# City of Surrey PLANNING & DEVELOPMENT REPORT File: 7908-0254-00

Planning Report Date: July 11, 2011

## **PROPOSAL:**

# Advisory Design Panel Minutes

CLIENT: LAKEWOOD HEIGHTS DEVELOPMENT LTD.	DESIGN :
	DRAWN:
PROJECT : PROPOSED MULTI-FAMILY DEVELOPMENT	
28TH AVE. & 156TH ST, SURREY	DATE :
SHEET CONTENTS:	
BUILDING ELEVATIONS	SCALE :
	1/8" = 1'-0"

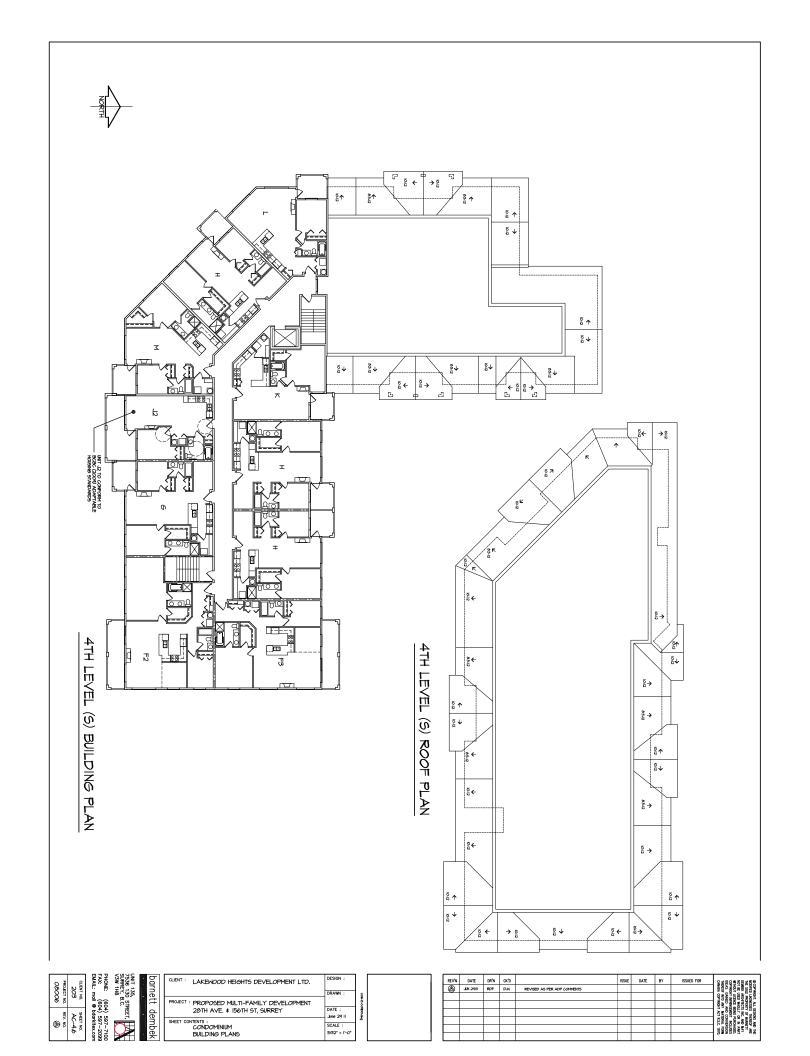
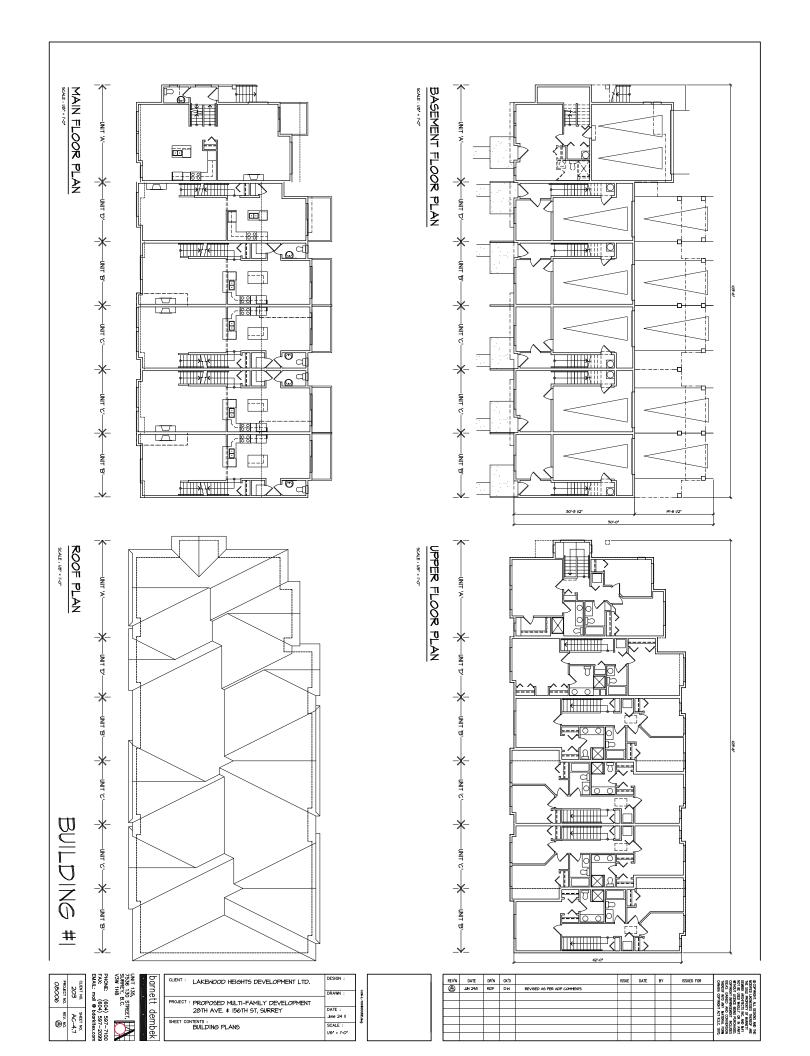
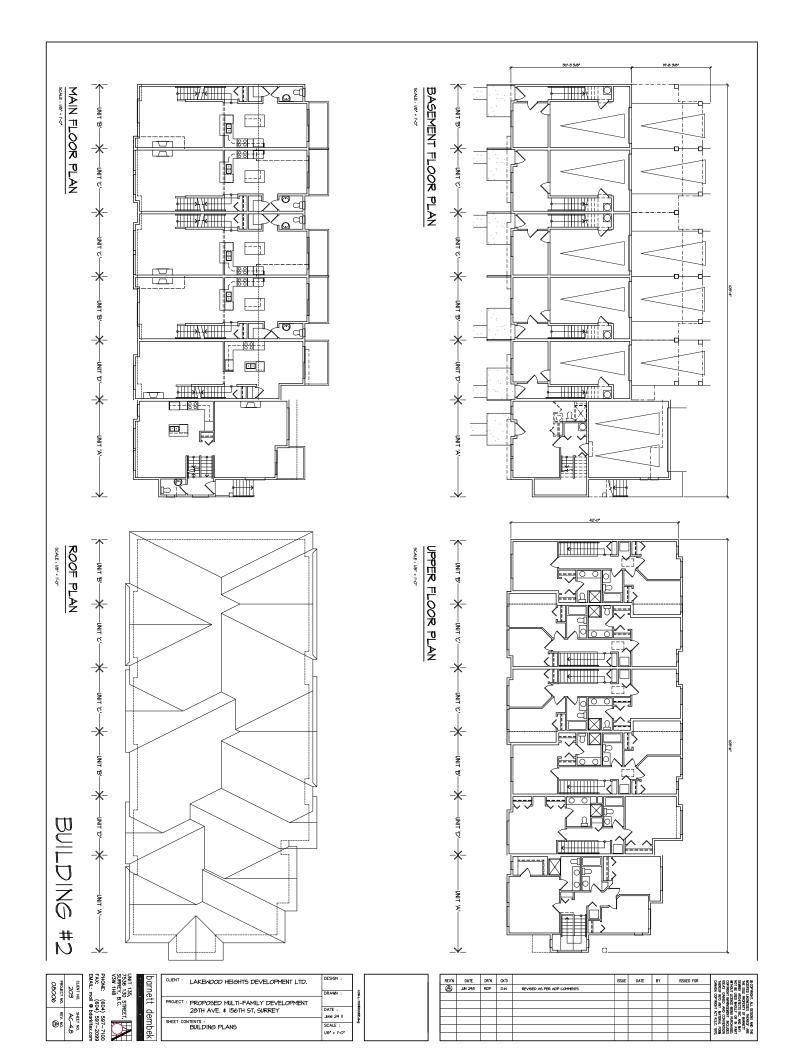
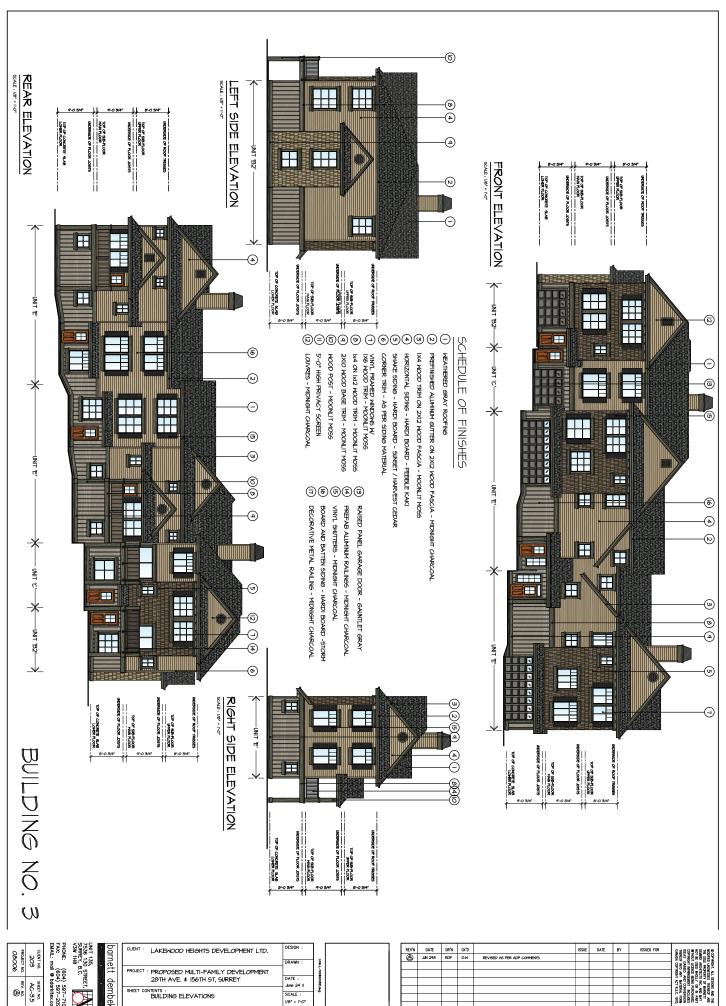
- As discussed with Tom at the meeting, it was felt that the 4th floor roof design was sufficient as is.
- Brick was added around the Condo Building to provide a heavier base.
- As discussed with Tom at the meeting, it was felt that the window elements, and the lineup of windows were sufficient as is.
- The condo units are provided with a flex area which gives the owner the option of using this space as a storage area if they wish.
- The color of the vertical elements of the townhouses, cedar shake siding and gables, are revised to a darker color to provide more contrast with the other colors of the building.

DATE	DR'N	CK,D		ISSUE	DATE	BY	ISSUED FOR	Ις:
JJN 29/II	RDP	DM	REVISED AS PER ADP COMMENTS					8
								] 8
								3
								1 5
								1 6
								1 8
								اة [

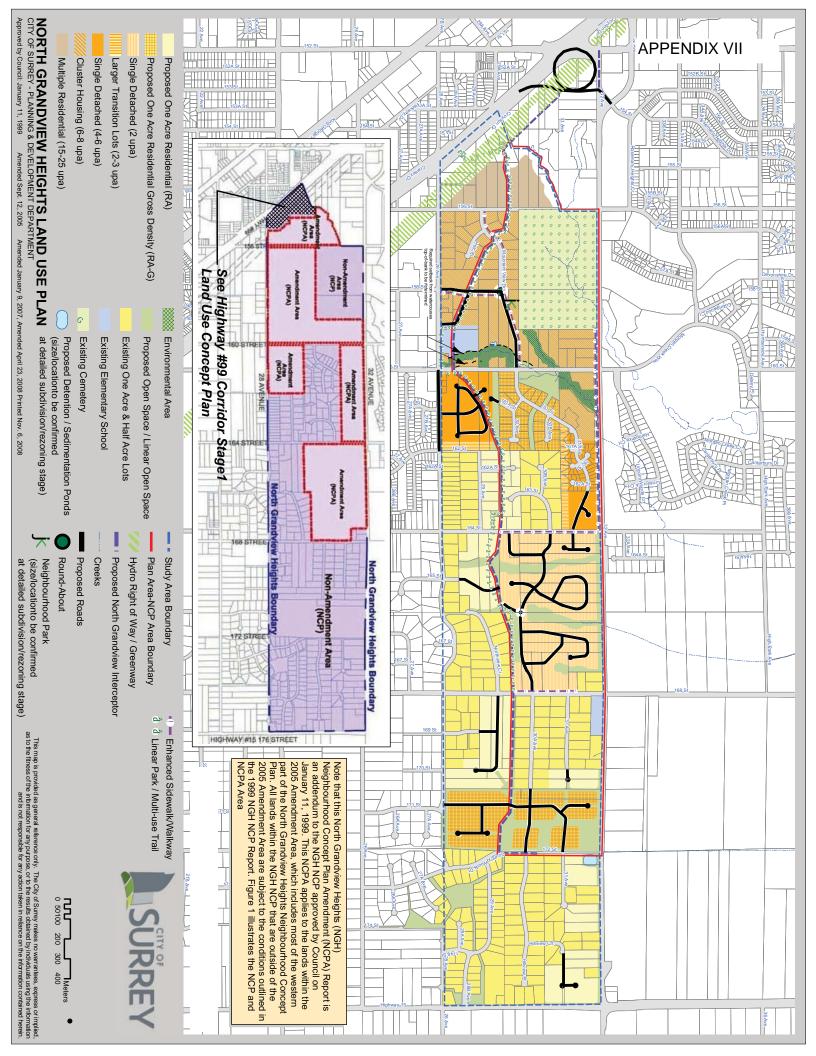
The 3D massing model has been revised to indicate the south building elevation, and a 3D blowup of the lower roof at the deck projections is provided.
